Parks & Trails Advisory Board Meeting

Meeting Date: Wednesday, April
13, 2022

Meeting Date: April 13, 2022
To: Parks and Trails Advisory Board
From: Rochelle Anderholm-Parsch, Parks and Recreation Director
Subject: Deer Meadows Revised Subdivision Proposal

RE: Roll Tide Properties Corp. - Deer Meadows Subdivision Revised Plan

STREET A CUL-DE-SAC

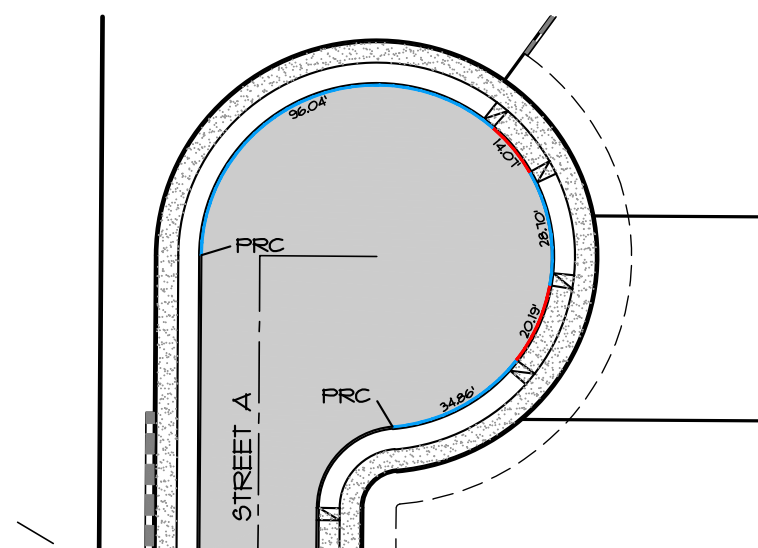
RESPONSE: **Exhibit 2** provides driveway width information for the Fawn Street and Street A cul-de-sacs. This exhibit demonstrates that the sum of the driveway widths for each cul-de-sac is less than 50%. SDC 17.98.100.F is satisfied.

TOTAL CIRCUMFERENCE FROM PRC TO PRC = 193.86'
 TOTAL GAPS = 159.60' (82.3%)
 TOTAL DRIVEWAY LENGTH = 34.26' (17.7%)
 (17.7% IS LESS THAN 50%. MEETS CODE)

DEER MEADOW T-INTERSECTION EXHIBIT

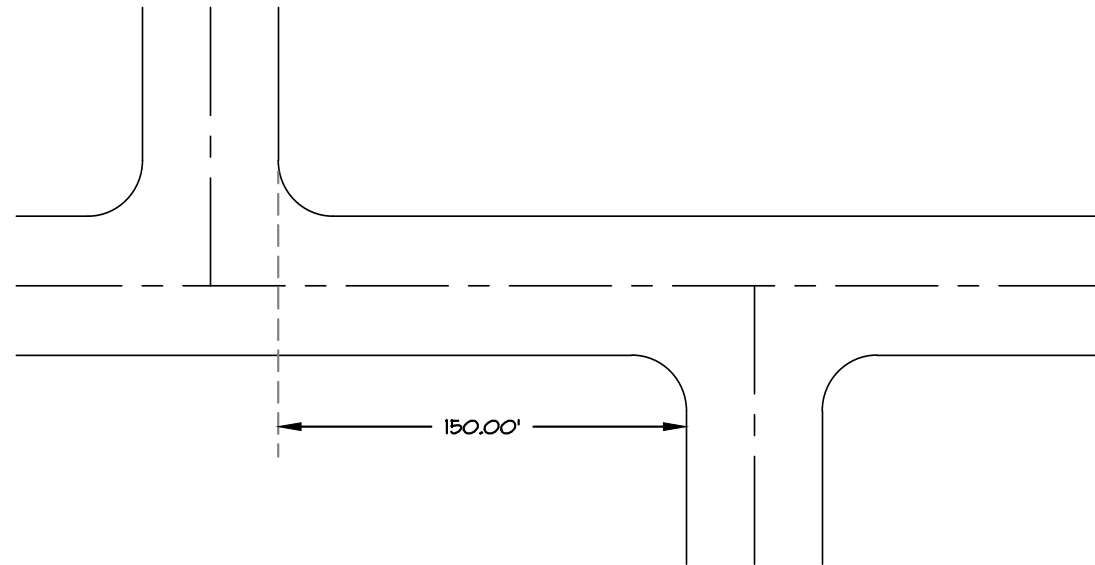
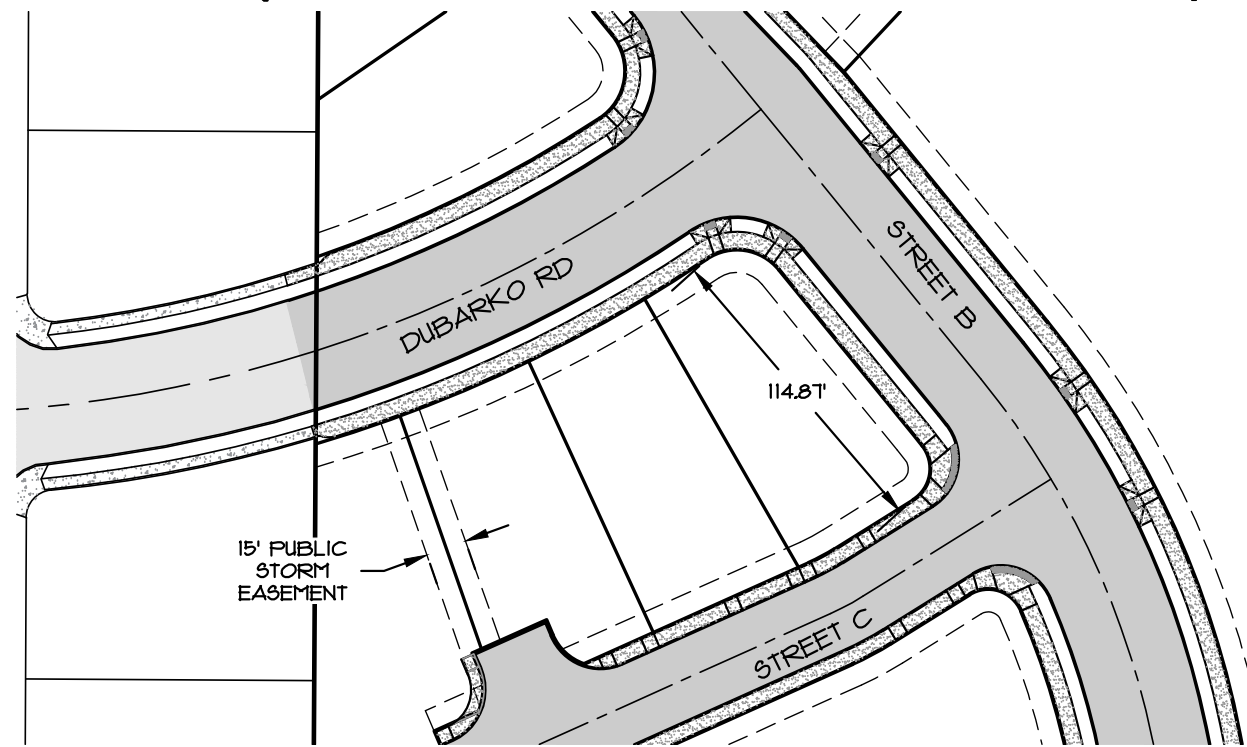
RESPONSE: This is not a permissible basis for denial because the 150-foot street spacing requirement does not apply to Street C. Subsection E.2 provides as follows:

PROPOSED T-INTERSECTION (NOT A STAGGERED T-INTERSECTION)

DUBARKO RD WITH 100' TANGENT EXHIBIT

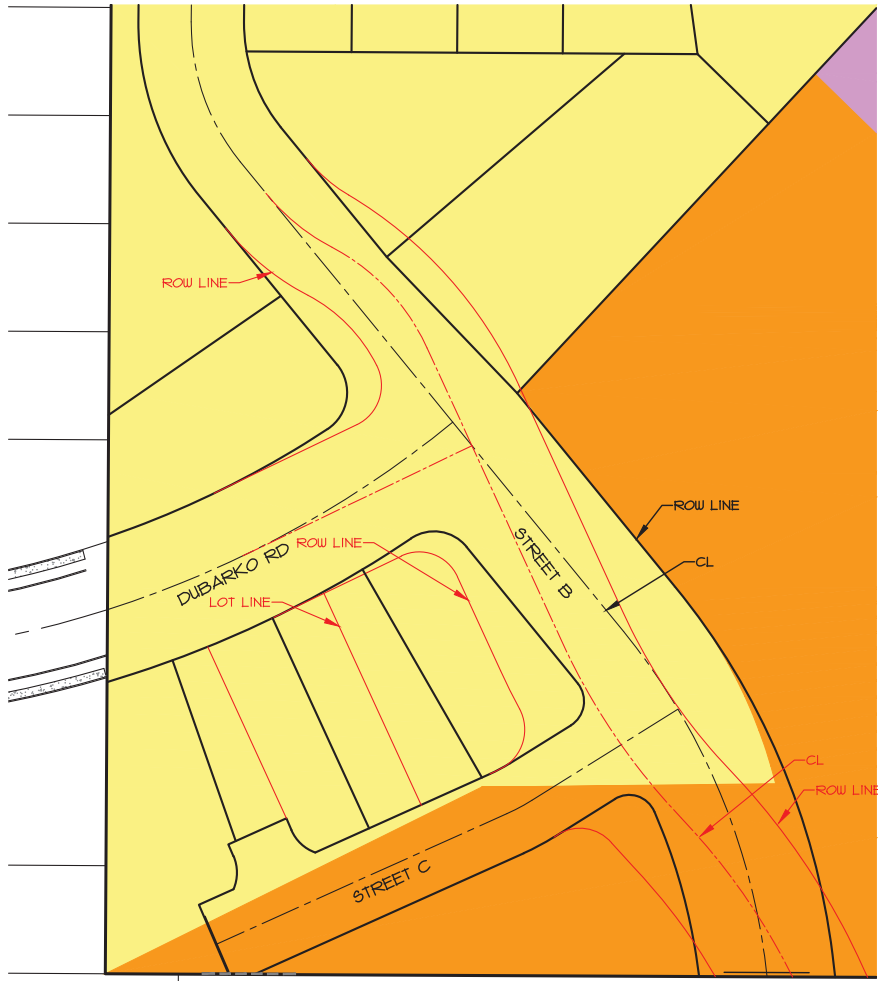
RESPONSE: This standard is not clear and objective because, by using the word “tangent,” it is not clear whether the standard applies only to curved intersections or to roughly straight intersections (as are proposed in the Application). Therefore, it is inapplicable under ORS 197.307(4).

Response: A note has been added to the revised plan indicating the required 100' long tangent centerline alignment will be detailed with the final engineering design in accordance with this section. The proposal complies with this standard and this item is no longer needed.

DEER MEADOWS SUBDIVISION
REVISED PLAT WITH
PARKLAND DEDICATION

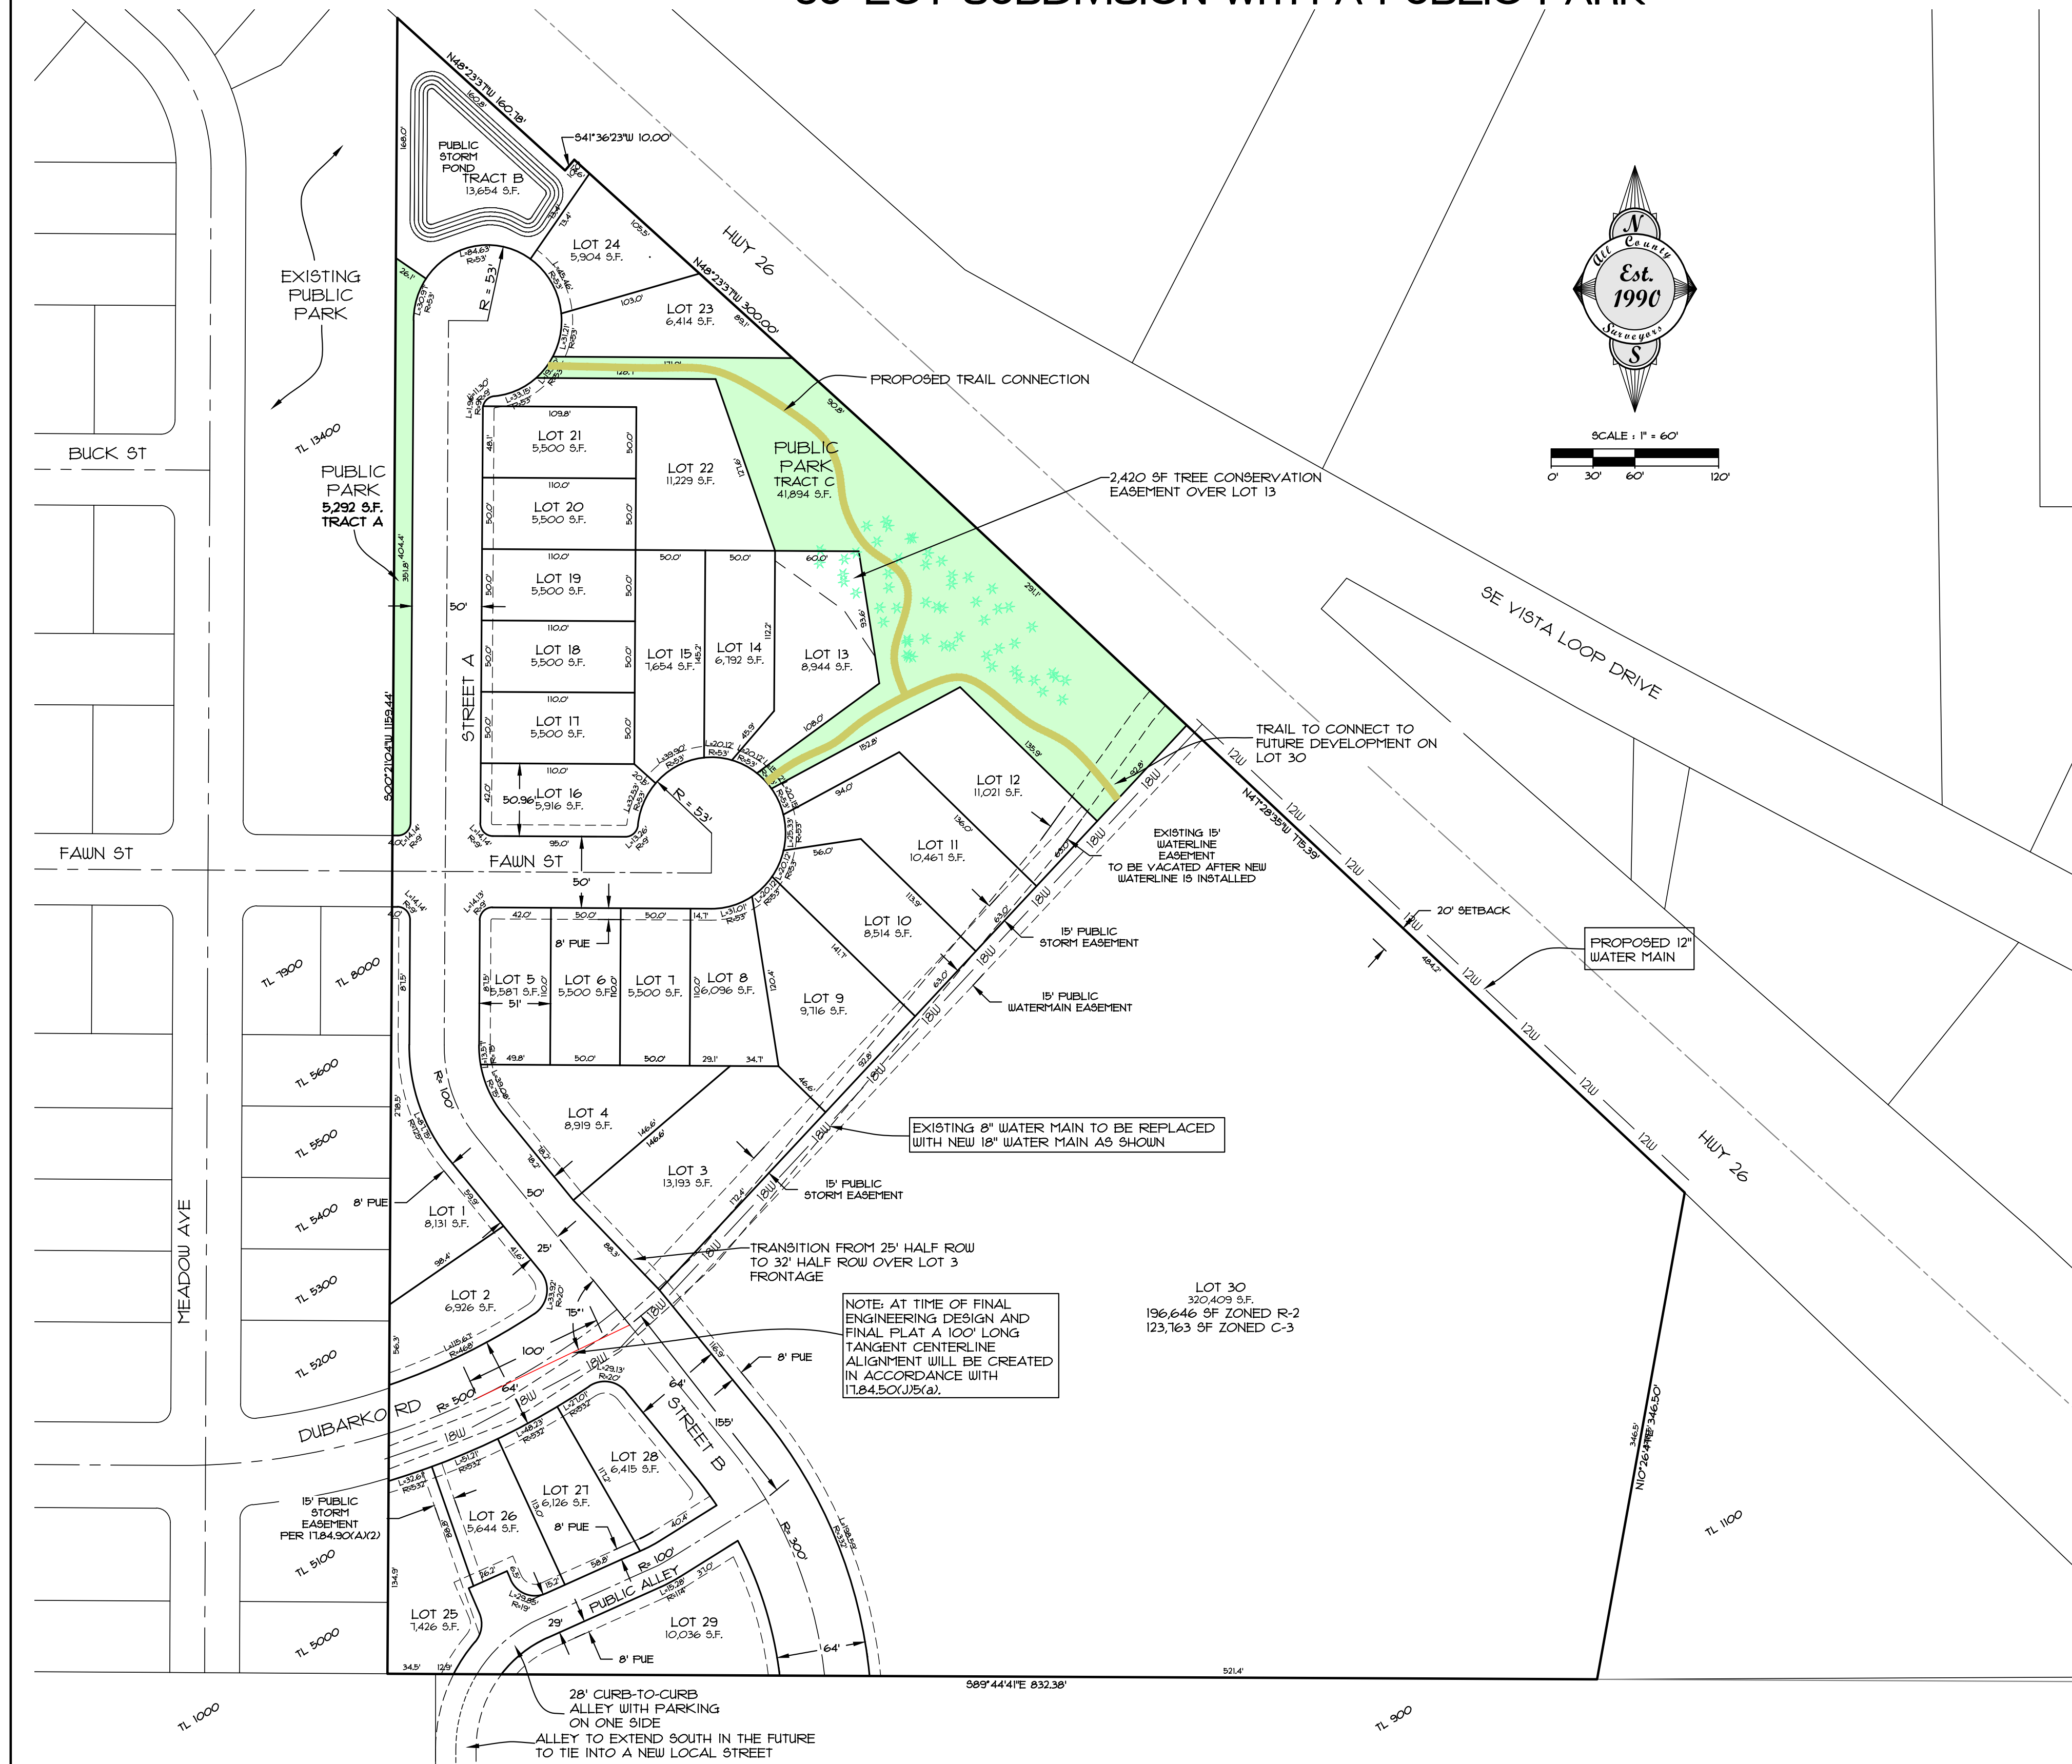
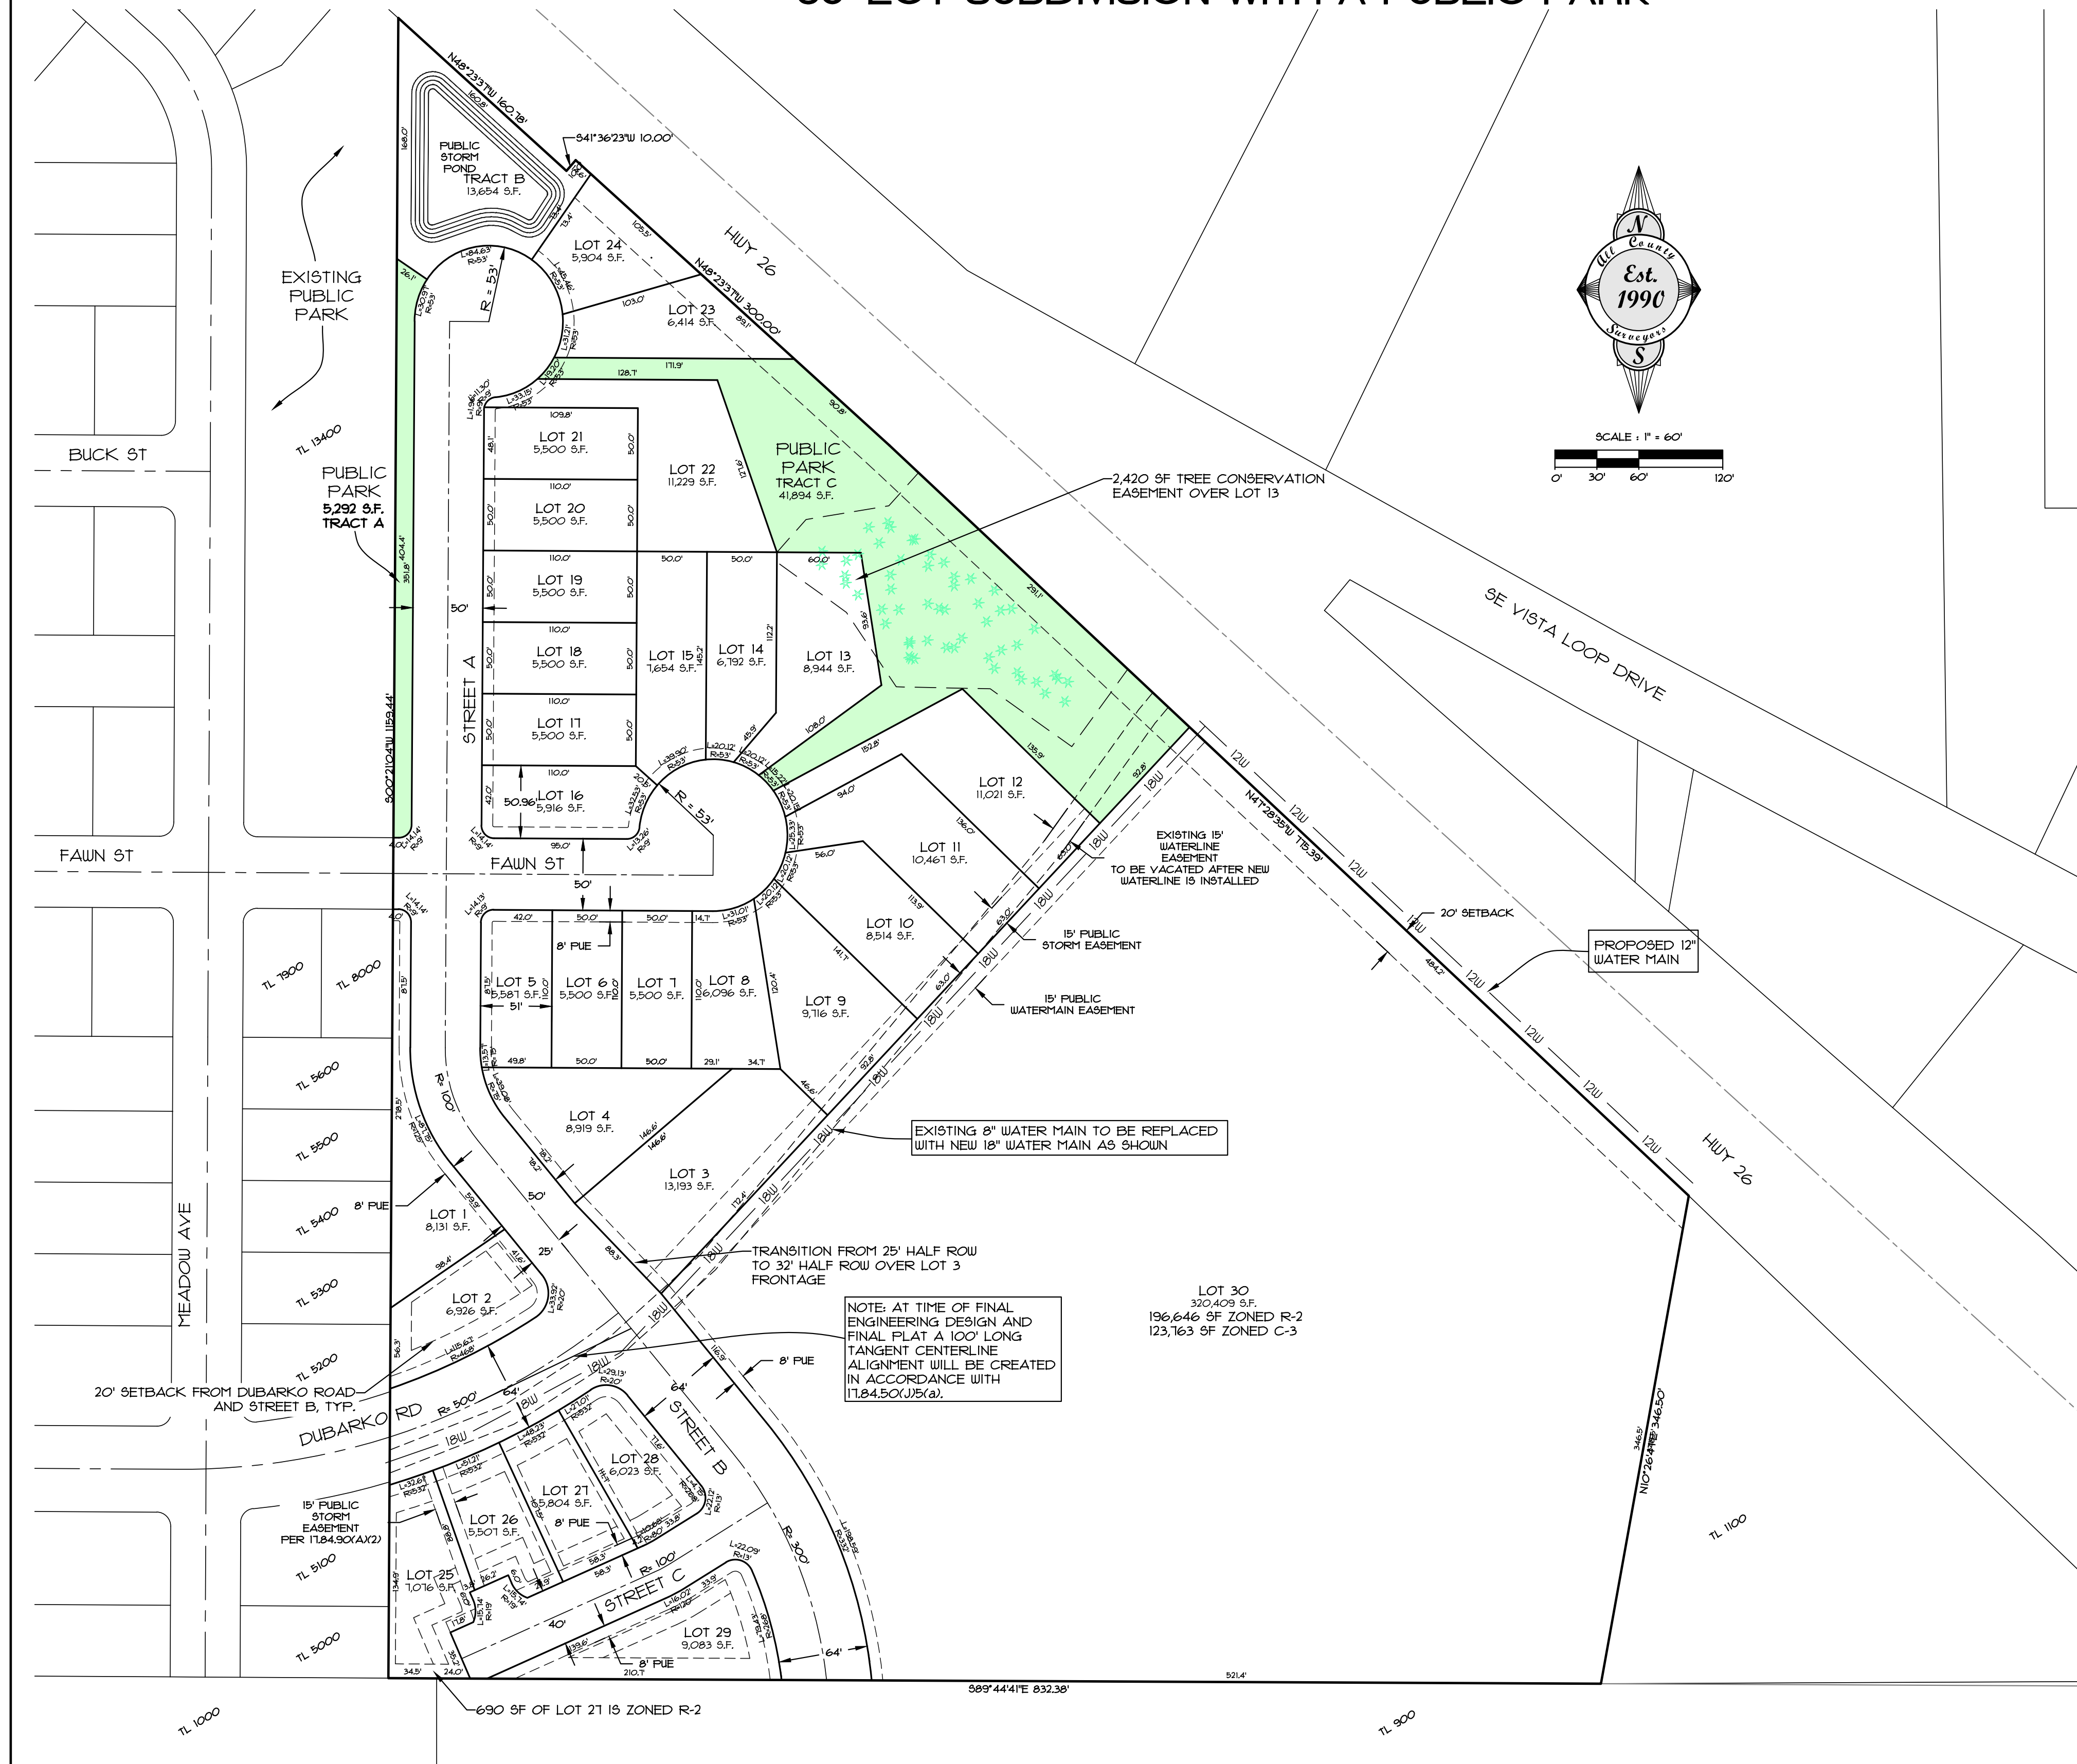
Support, provide comment, or deny support, of the 0.93 acre parkland dedication in two separate tracks with only 0.12 additional acres abutting the existing Deer Pointe Park property.

The proposed revised plan has two non-contiguous tracts. TRACT A, which totals 5,292 S.F. and is adjacent to the existing Deer Point Neighborhood Park. TRACT B is along highway 26 and totals 41,894 S.F.⁷. In the plans there is no sidewalk proposed, and the trees on TRACT C are retention trees and cannot be cut down by the City. Total proposed non-contiguous land dedication is 47,186 S.F. or 1.082 acres. Although, as noted above the proposed plat also includes a note that this parkland could be reduced to a total of 0.93 acres.

Staff does not support the Deer Meadows Revised Plat. Staff would be open to discussing and supporting other options such as a land swap.

Response: The revised plan now features a new 1.08 acre parkland dedication (Tracts A and C). Based on 30 lots in the revised plan, Chapter 17.86 requires 0.93 acres of parkland or payment of a fee in lieu. (28 single family lots x 3 x .0043 = 0.361 rounded to 0.36 acres, 66 multifamily units x 2 x .0043 = 0.567 rounded to 0.57, 0.36 + 0.57 = 0.93). The revised plan as proposed exceeds the requirements of Chapter 17.86 and this recommendation is longer needed.

PARKLAND DEDICATION SHOWN AT +/- 1 ACRE. MINIMUM REQUIRED AT TIME OF FINAL PLAT TO BE 0.93 ACRES (40,911 SF). ADJUSTMENTS TO LOT LINES WILL BE MADE AT TIME OF FINAL PLAT TO PROVIDE 0.93 ACRES OR MORE.
